LiDAR Quality Assurance (QA) Report
Louisiana LiDAR ARRA Project - Region 2
October 11, 2011

Submitted to:
USGS

Prepared by:
 **Dewberry**

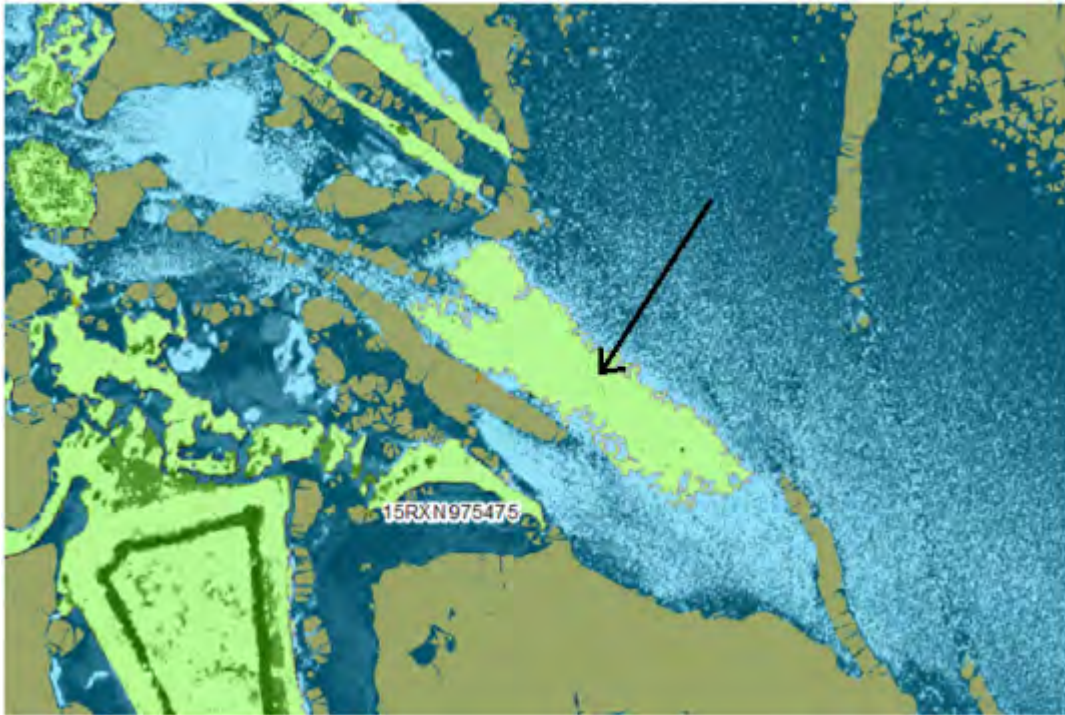
Figure 21 – Island breaklines are colored transparent green, Tidal water breaklines are transparent blue. The LiDAR intensity image is visible underneath the breaklines. Voids in the intensity image which represent water display in tan. A large portion of water has been mistakenly captured within an island breakline.

Figure 22 - Island breaklines are colored transparent green, Tidal water breaklines are transparent blue. The LiDAR intensity image is visible underneath the breaklines. Voids in the intensity image which represent water display in tan. The tidal water breaklines has been correctly adjusted to remove the issue.

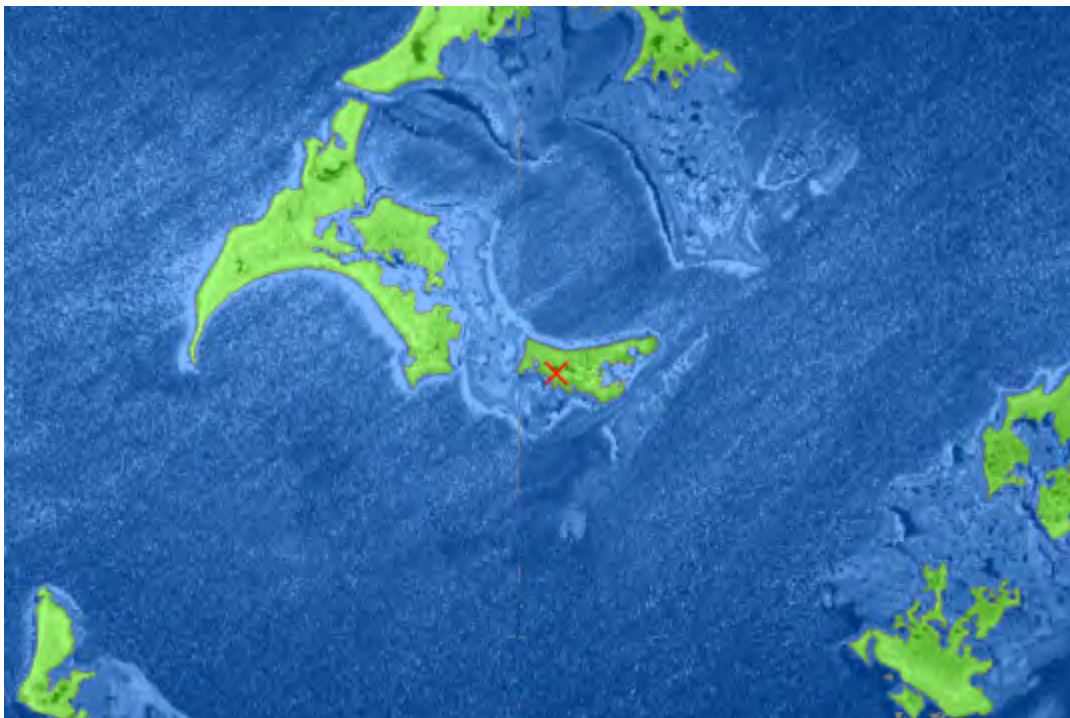
Figure 25- Tile 15RYN11265, first delivery. Island breaklines are colored transparent green, Tidal water breaklines are transparent blue. The LiDAR intensity image is visible underneath the breaklines. The image above shows ground that was captured as part of the tidal water breaklines.

Figure 26- Figure 27- Tile 15RYN11265, third delivery. Island breaklines are colored transparent green, Tidal water breaklines are transparent blue. The LiDAR intensity image is visible underneath the breaklines. The image above shows that the ground was appropriately changed to the island breakline feature class.
